Re: City of Palmdale Hybrid Power Plant Project: Docket No. 08-AFC-9

PALMDALE HYBRID POWER PROJECT (08-AFC-09) CEC STAFF SET 2 DATA REQUESTS 152 - 153	
Technical Area: Visual Resources	Response Date: June 2, 2009

**APPLICANT'S REVISED RESPONSES TO CEC DATA REQUESTS 152-153
REGARDING VISUAL RESOURCES**

Visual Resources
Attachment DR-153
Fogging Frequency Curve

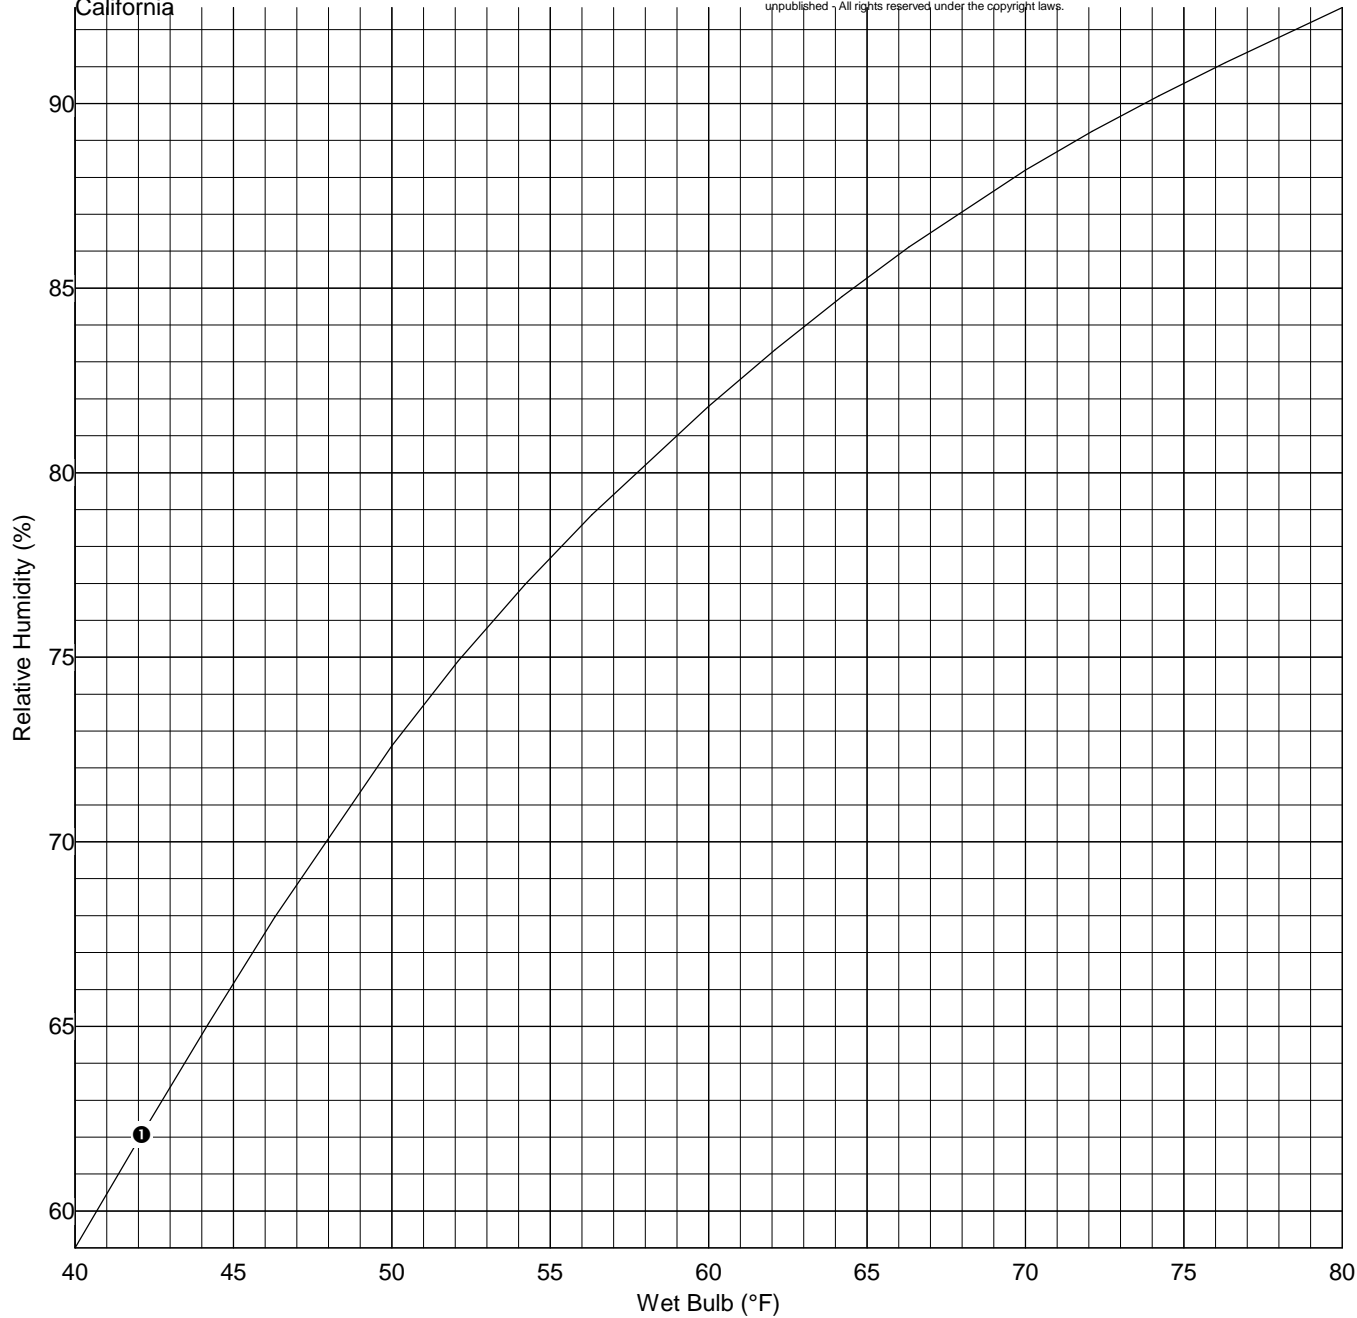
Please provide the cooling tower manufacturer and model number information and a fogging frequency curve from the cooling tower vendor, if available, that corresponds to the altitude of the project site.

The cooling tower design is based on an SPX/Marley F4910-5.3-10B cooling tower. A revised Fogging Frequency Curve is provided as Attachment DR-153 at the end of this section.
